# **REVISED RESPONSE TO REQUEST FOR ADDITIONAL INFORMATION**

APR1400 Design Certification

Docket No. 52-046

RAI No.:	244-8326	
SRP Section:	09.03.03 – Equipment and Floor Drainage Systems	
Application Section:	9.3.3	
Date of RAI Issue:	10/14/2015

Figure. Turbine Generator Building Drain System

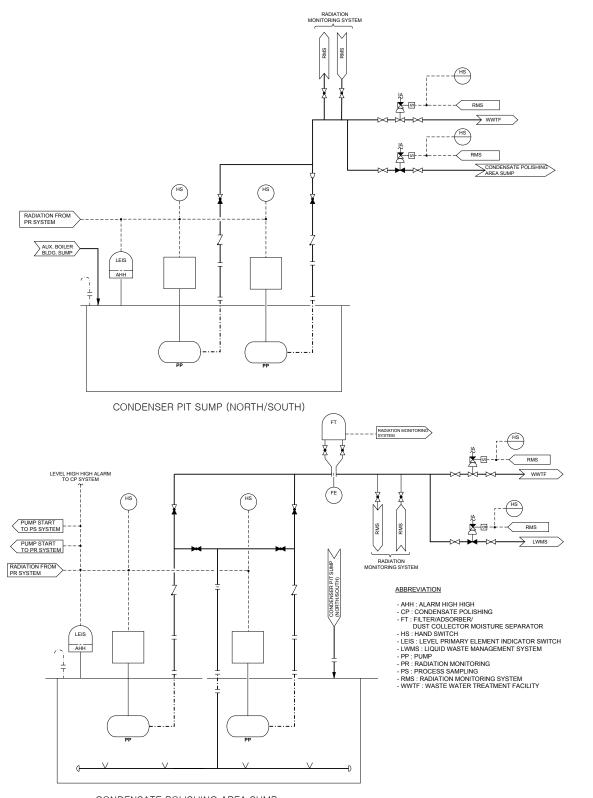
The applicant is requested to provide additional information as to how these valves change the flow path in order to conclude whether this is an automatic function or operator action is required.

The turbine generator building drain system consists of condenser pit sumps (north/south) and a condensate polishing area sump. The below figure shows the interconnection of the turbine generator building drain system between the liquid waste management system (LWMS) and the waste water treatment facility (WWTF).

All sump pumps discharge into the WWTF as long as no contamination fluid is present. The discharge from the condensate polishing area sump is monitored for process radiation. Upon detection of radioactivity, the operating sump pump is stopped automatically by the RMS signal. The discharge valve to WWTF is closed, and the discharge valve to LWMS is opened simultaneously. Then, the sump pump is manually started. The flow is then diverted to the LWMS.

The discharges from the condenser pit sumps are monitored for process radiation. Upon detection of radioactivity, the operating sump pumps are stopped automatically by the RMS signal. The discharge valve to the WWTF is closed, and the discharge valve to condensate polishing area sump is opened simultaneously. Then, the sump pump is manually started. The flow is then diverted to the LWMS.

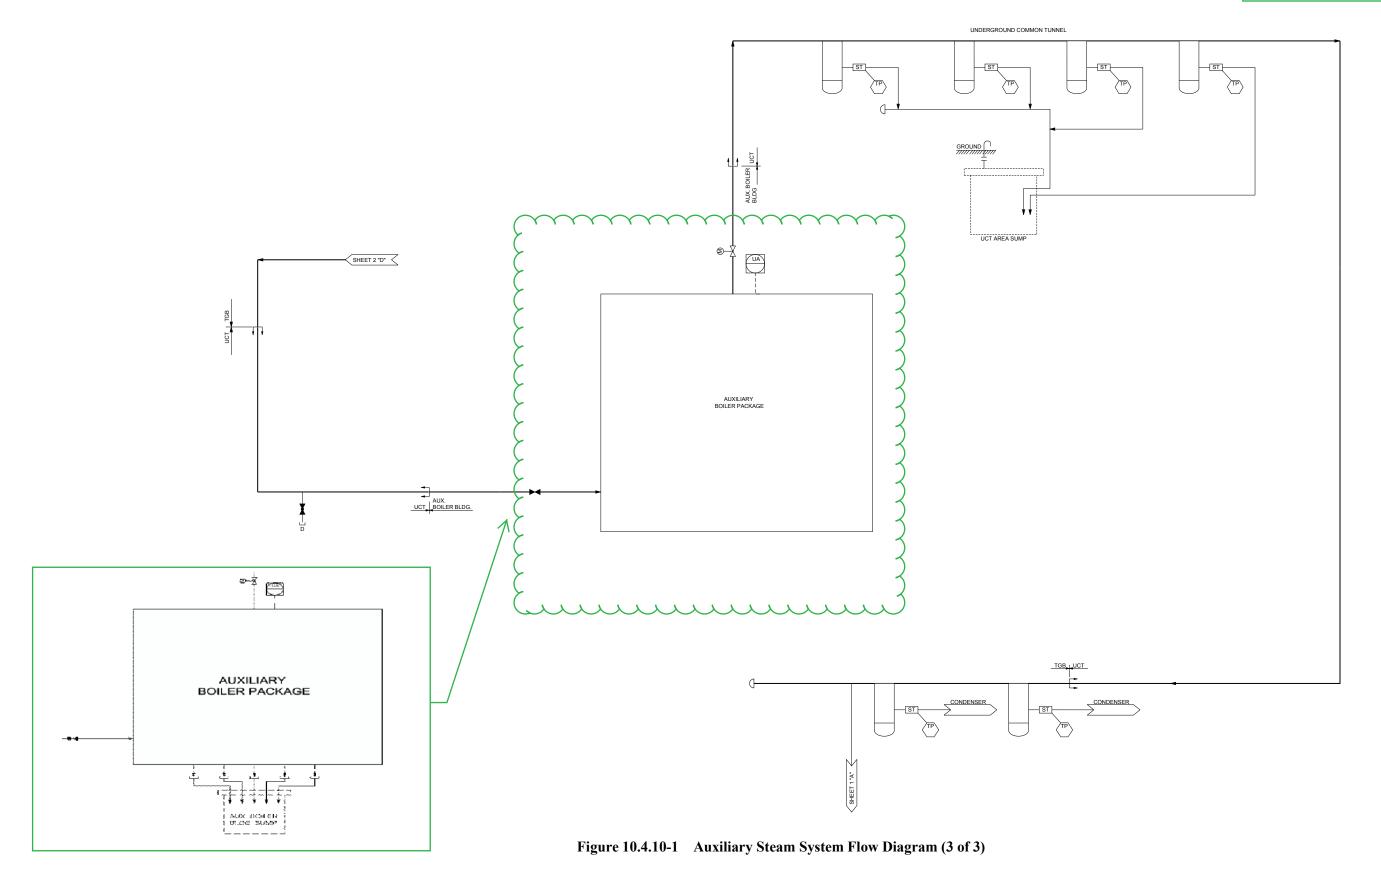
Therefore, DCD Section 10.4.10.2.1 and 10.4.10.2.3 will be revised in accordance with the above description. DCD Tier 2, Figure 10.4.10-1 (Sheet 3 of 3) will include the auxiliary boiler building sump and lines.

c. The Auxiliary Boiler Blowdown and drains are routed to the Auxiliary Boiler Building Sump and then are routed to the turbine generator building (TGB) sump for radiation monitoring. When contamination level of the drains is detected and exceeds a predetermined setpoint, they are routed to the LWMS for processing and release via the condensate polishing area sump.
